AGENDA

DEVELOPMENT REVIEW COMMITTEE

September 8, 2004

Subject: SP-098-04, Warhill Green (Construction Plan)

DETECTOR CHECK VALVE ASSEMBLY FOR FIRE SUPPRESSION SYSTEMS	
DWG NO. W17.0	SCALE: NONE
DWN BY:	DATE: JUNE 2004

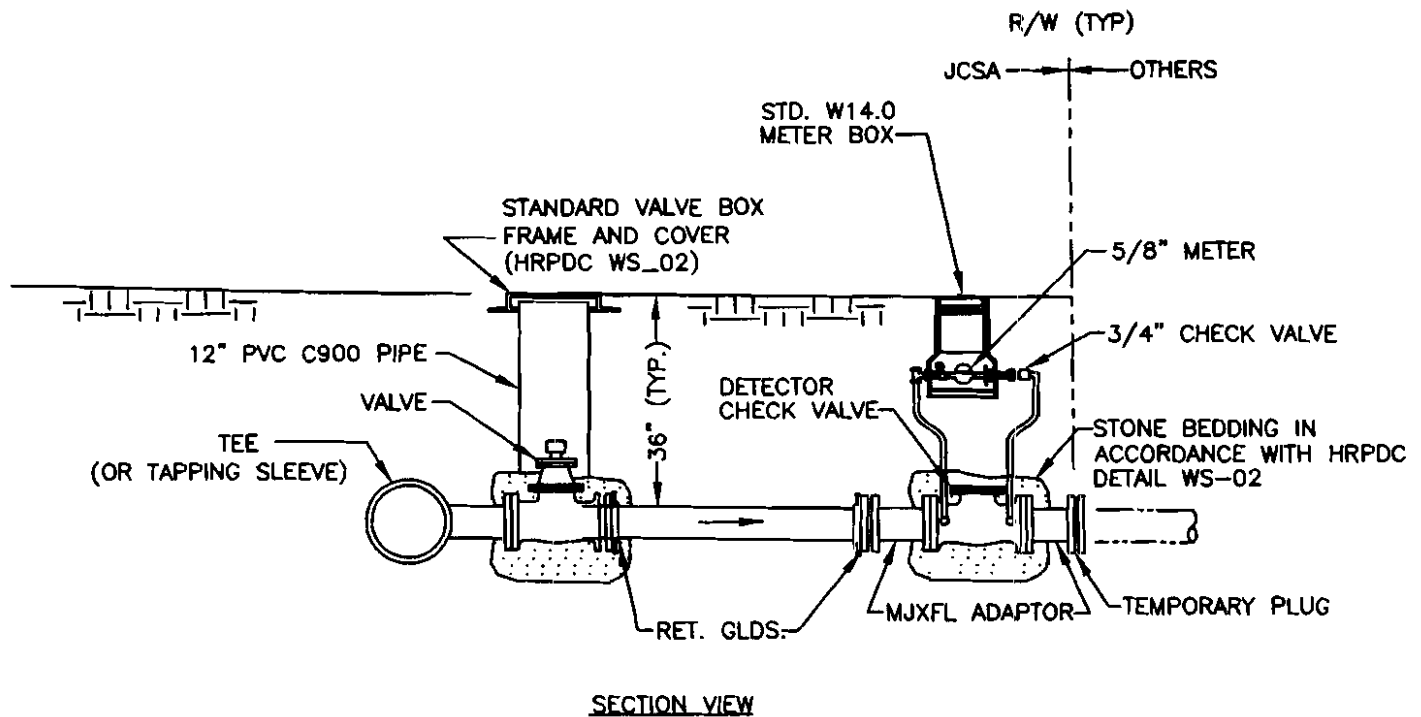
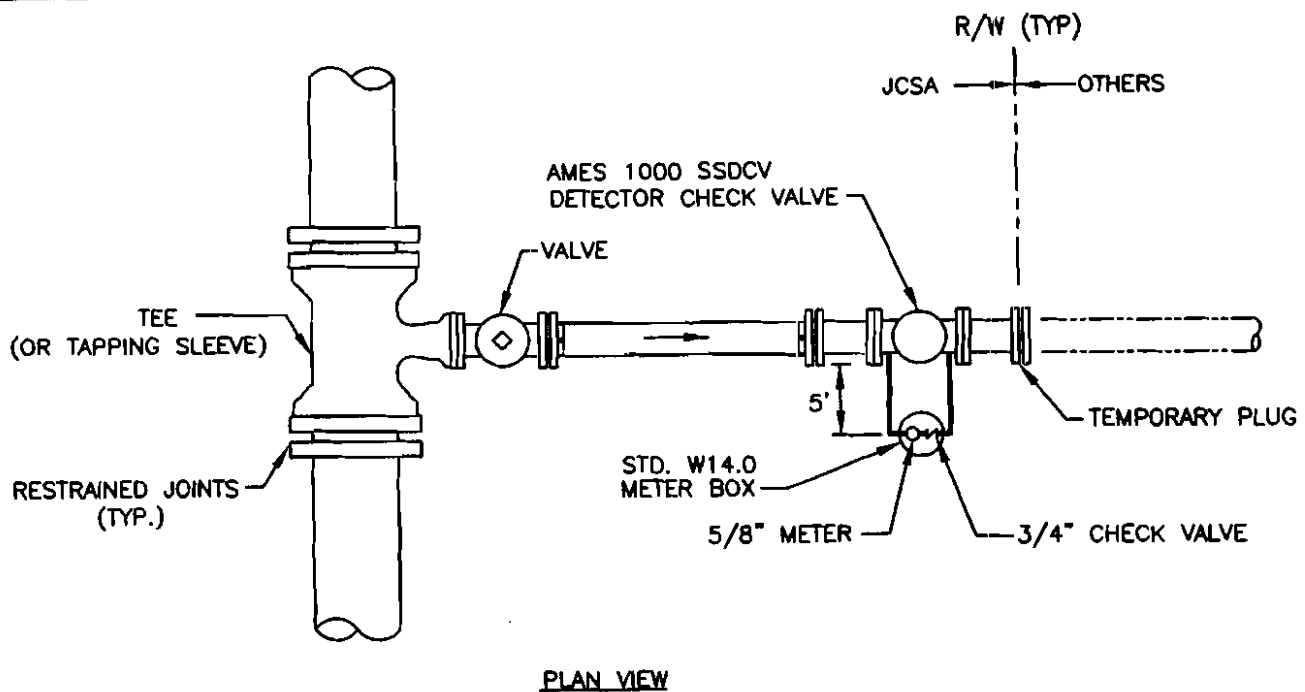
1. Since the proposed fire supply system will be private, a backflow prevention device (low hazard condition) shall be provided on the line. Attached is a "Detector Check Valve Assembly" detail which can be used for backflow prevention. The detector check valve shall be located at the right-of-way line. This will delineate the end of JCSA's responsibility for the fire supply line. The detail shall be modified by the Applicant to show the 5/8" meter located outside of the paved area, preferably adjacent to the proposed 2-inch master meter. Water meter location and size shall be clearly identified on the site plan.
